Housing Development,
Cappagh Road,
Co. Galway
Stage 1
Road Safety Audit

Document Control Sheet

Document Reference	TR01 Road Safety Audit
Client:	Galway City Council
Project Reference	12031

Figure 2-2: Footpath – Road Edge

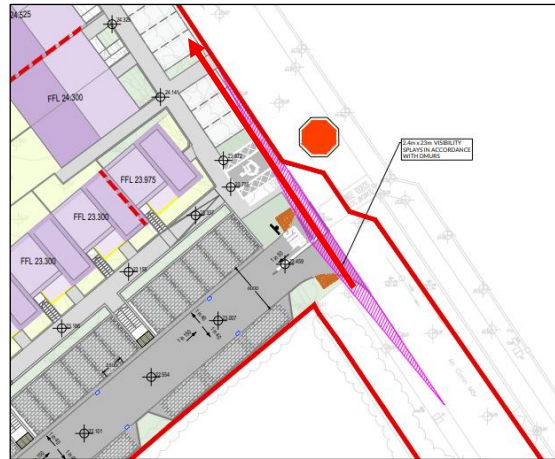
Entrance B Existing Footpath

The Audit Team noted on the design drawings the removal of the existing footpath. The Audit Team is concerned the desire line for Vulnerable Road User (VRU) is not being met. This may result in VRU walking behind vehicles utilising the perpendicular parking increasing the potential for a collision between a VRU and a vehicle.

The design team should retain the existing footpath along the road edge.

Figure 2-4: Tactile Pavement Alignment at Proposed Site Entrance

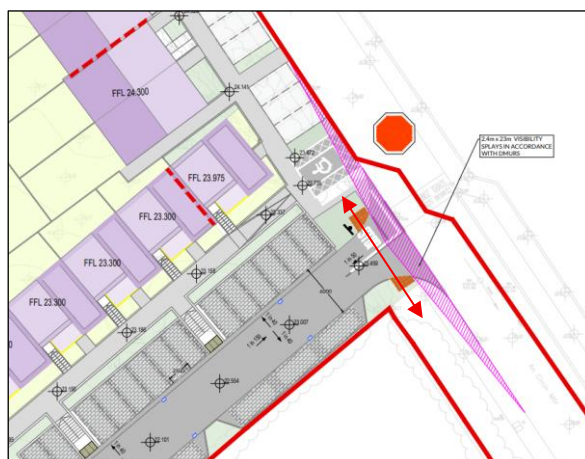
Entrance B Tactile Paving

The Audit Team noted on the design drawings the proposed crossing location. The Audit Team are concerned that the proposed crossing directs VRU into the grassed area or a parking vehicle. This may lead to confusion by the visually impaired VRU, directing them into the path of a parked/moving vehicle which may result in a potential collision.

The design team should ensure VRU are led to a footway at the pedestrian crossing.

Figure 2-5: AutoTrack Analysis at Proposed Site Entrance

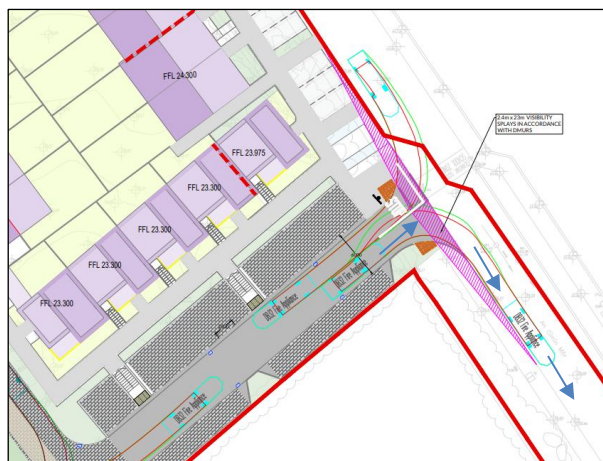
Entrance B Swept Path Analysis

The Audit Team noted on the design drawings the undertaken swept path analysis at the junction. The Audit Team are concerned that AutoTrack analysis was carried out on the incorrect side of the road, which does not accurately represent the intended vehicle movement. This may result in inadequate turning space and or kerb overruns, increasing the risk of a collision with another road users.

The design team should update the swept path analysis for all emergency vehicles and ensure the vehicles remain within the carriageway

Figure 2-7: Footpath - Housing Development

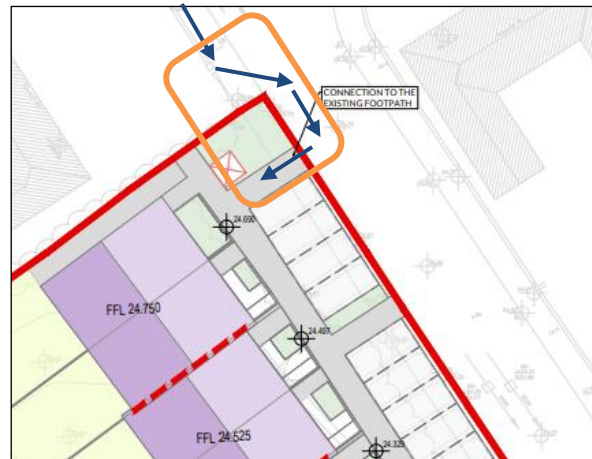
Entrance B Footpath – Commencement

The Audit Team noted on the design drawings the commencement of the public footpath. The Audit Team are concerned that a VRU who is wheel chair bound will have to enter the carriageway to continue utilising the footpath. Increasing the potential for a collision between a VRU and a vehicle.

The design team should ensure a continuous footpath is provided for along the road edge.

Figure 2-8: Proposed Stop Line

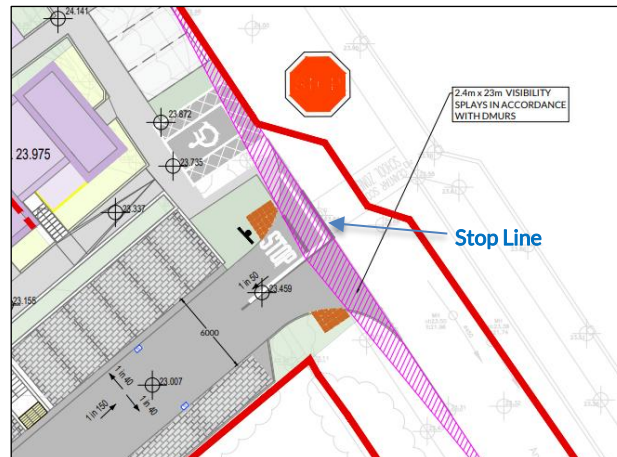
Entrance B Stop Line - Position

The Audit Team noted on the design drawings the location of the proposed stop line. The Audit Team is concerned that the stop line too close to the road edge. During low light foggy condition, vehicles may overrun the junction. This may result in a side impact type collision with approaching vehicles.

The design team should ensure all road markings are in line with the Traffic Signs Manual (TSM).

Figure 2-9: Proposed Parking Spaces

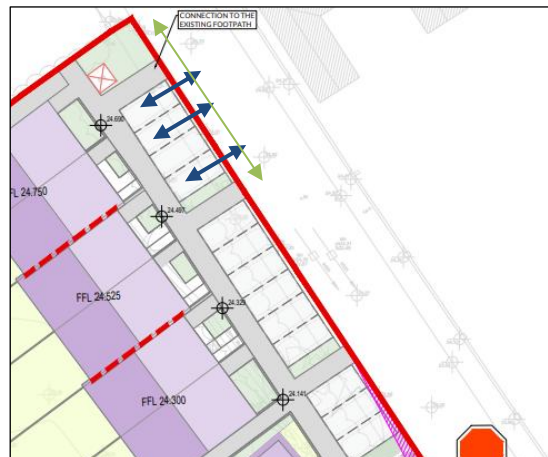
Entrance B Perpendicular Parking Spaces

The Audit Team noted on the design drawings the location of the proposed parking. The Audit Team is concerned that the parking will result in drivers driving into the parking spaces, creating blind spots when vehicles reverse out on the mainline. This may result in a side impact type collision with approaching vehicles and/or a collision with VRU walking along the road edge to footpath.

The design team should prevent parking reversing out onto the mainline.

Figure 2-10: No Existing Crossing from School to Proposed Site

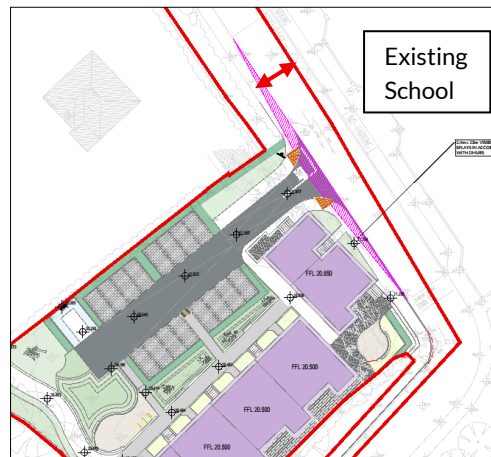
Connectivity

The Audit Team observed onsite the location of the existing school. The Audit Team are concerned the desire line between the two residential sites, sites A and B and the existing school has not been incorporated in the design. This may result in a collision between a VRU and a vehicle.

The design team should ensure a pedestrian crossing is provided.
